Access Compliance Report

Public Rights-of-Way

Intersection ID: 42867	Main Street: IDLEWILD_RD_NORTH	Cross Street: ROSEHALL_DR	Location: SE
ADA ID: 9DDDB51454E1D	Ramp Type: PerpDiag	Initial Pass/Fail: Fail	Overall Compliance: No
Severity Score: 12.5			
Codes/Mitigation Info/Possible Solution		Field Measurements/Component Compliance

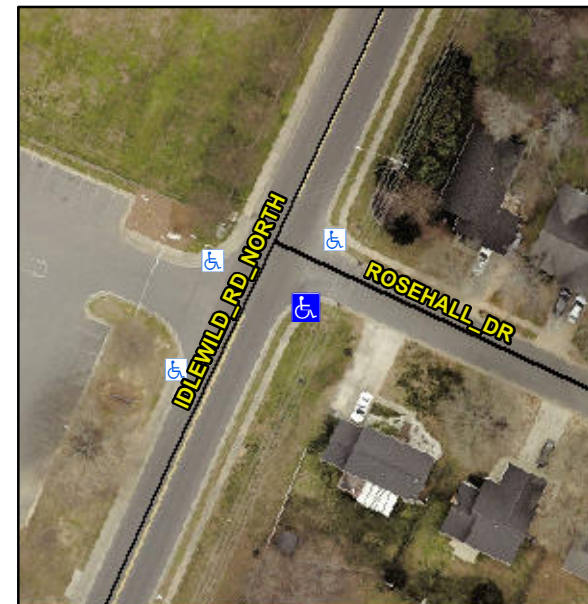
Not Found, R304.2.2

Compliance	Description	Data	Compliance	Description	Data
N/A	Ramp Length (in)	54.0	No	Ramp Slope (%)	9.2
Yes	Ramp Width (in)	48.0	Yes	Ramp XSlope (%)	1.1
N/A	Flare Type LT	N/A	N/A	Flare Type RT	N/A
N/A	Flare Slope LT (%)	N/A	N/A	Flare Slope RT (%)	N/A
N/A	Flare Traversable LT?	N/A	N/A	Flare Traversable RT?	N/A
N/A	Landing Length (in)	N/A	N/A	DWS Provided?	N/A
N/A	Landing Width (in)	N/A	N/A	DWS Contrast?	N/A
N/A	Landing Slope (%)	N/A	N/A	DWS Length (in)	N/A
N/A	Landing X Slope (%)	N/A	N/A	DWS Full Width?	N/A
N/A	Landing Curb? (Y/N)	N/A	N/A	DWS Offset (in)	N/A
N/A	Shared Landing?	N/A			
N/A	Gutter Ponding?	N/A	N/A	Gutter Slope (%)	N/A
N/A	Gutter Lip Ht (in)	N/A	N/A	Gutter X Slope (%)	N/A
N/A	Painted X Walk1?	No	N/A	Painted X Walk2?	No
	X Walk 1 Direction	To NE		X Walk 2 Direction	To NW
N/A	X Walk 1 Width (in)	N/A	N/A	X Walk 2 Width (in)	N/A
	X Walk 1 Slope (%)	0.2		X Walk 2 Slope (%)	1.2
	X Walk 1 X Slope (%)	0.9		X Walk 2 X Slope (%)	1.1

Remove & Replace Curb Ramp With Two New Directional Ramps or Equivalent.
